VILLA D'ESTE JSP 17-52 AND ZONING MAP AMENDMENT 18.718

Public hearing at the request of Cambridge of Novi, LLC for Planning Commission's recommendation to City Council for a Planned Rezoning Overlay Concept Plan associated with a Zoning Map amendment, to rezone from RA (Residential Acreage) to R-1 (One-Family Residential). The subject property is approximately 49 acres and is located east of Napier Road and on the north side of Nine Mile Road (Section 29, 30). The applicant is proposing a 53-unit single-family ranch housing development (for sale).

PRO CONCEPT PLAN

PLANNING REVIEW

OVERALL PLAN

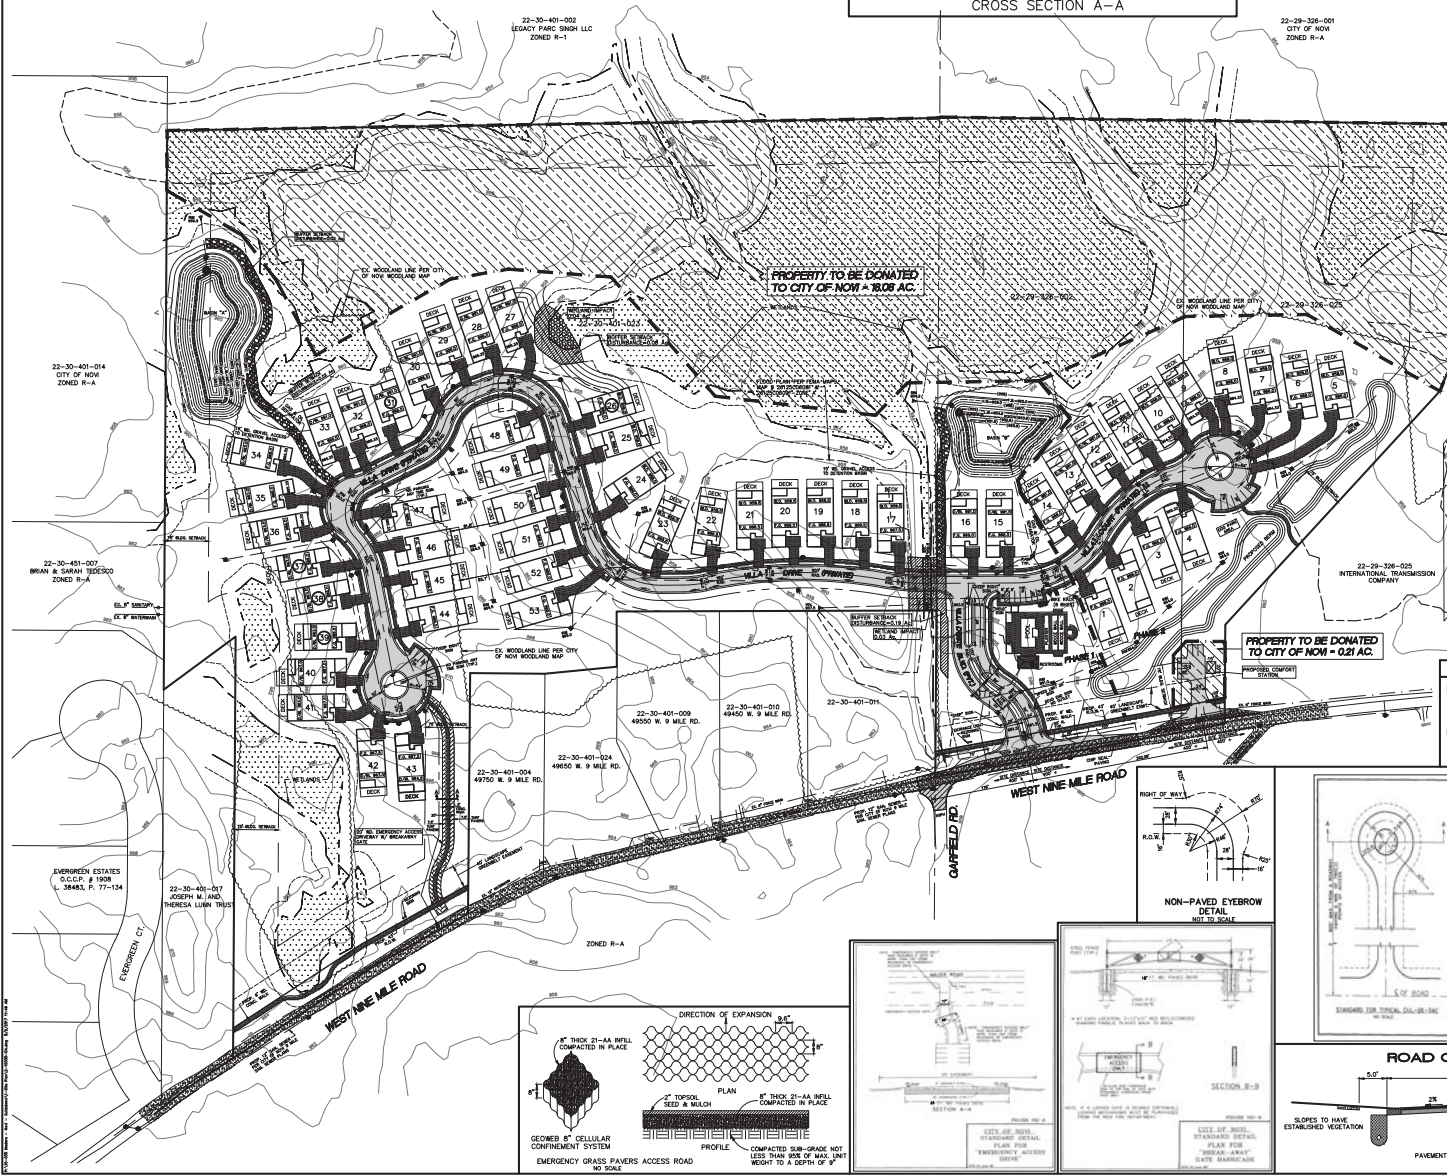
- See sheet 2 for density calculations; overall site density = 1.10 units/acre < 1.65 max (R-1)
- As requested, conceptual lot lines have been shown on the Lot Detail on sheet 2 to assist in specifying deviations required. If required for implementation of the site plan as proposed, **a deviation is requested.**

- 21 parking spaces are provided and shown on sheet 2, which meets requirements so a deviation is not required.
- Bicycle Parking is provided and shown on sheet 2, also per requirements.
- Parking Lot Design and Accessory Structures: No deviations are being requested at this time.

- Drives within 200' of the site have been shown on sheet 2. Dimensions from the site entry to Garfield Road and the proposed comfort station driveway are also provided.
- Stub streets are not provided due to environmental constraints. **A deviation from this requirement is requested.**
- Right-of-Way permit will be obtained.
- See sheet 2 for 43' ½ ROW width and 6' wide pathway. Pathway is show at 1' off ROW line except along the westerly frontage where it deviates to avoid an existing wetland.
- One section corner tie is provided on sheet 1. A second section corner tie is being surveyed at this time and will be provided in the next submittal.
 - 10. These items will be provided at the time of Final Site Plan Approval.

- With regard to placement of sidewalks through the roadway approach, **a deviation from this requirement is requested.**
- Detailed grading will be provided at the time of Final Site Plan Approval.

- For internal roadways, see pavement cross sections on sheet 2 & 3. Also, please note that pavement improvements to both 9 Mile and Garfield Roads are proposed to be Chipseal pavement. Therefore if this does not meet the city ordinance, **a deviation is requested.**

- **A deviation is requested** for the proposed non-paved eyebrows.
- As requested, the sidewalk along 9 Mile has been revised to 6' wide. See sheet 2.
- A note has been added to sheet 2 regarding private streets.

- FEMA Flood Zone A has been identified and labeled on the site plan, sheet 2.
- Floodplain permits will be applied for once the Concept Plan layout has been approved.

- General Traffic Flow (d) - **A deviation is requested** for the minimum radius requirement of 230' for internal roadways.
- Parking Facilities (a-d) – vehicle and bicycle parking facilities are to be provided and built per city ordinance. Bicycle parking is shown on sheet 2. Also on sheet 2, signage for no parking has been provided and indicated at the cul-de-sacs and eyebrows.
- Sidewalk Requirements – see response to Engineering Review above, items 16-17. Ramps, crosswalks and detectable warning surfaces will be provided and designed per ADA Standards. Details will be provided with the Final Site Plan.
- Signing and Striping shall comply with the Michigan manual on Uniform Traffic Control Devices with details to be provided on the Final Site Plan.
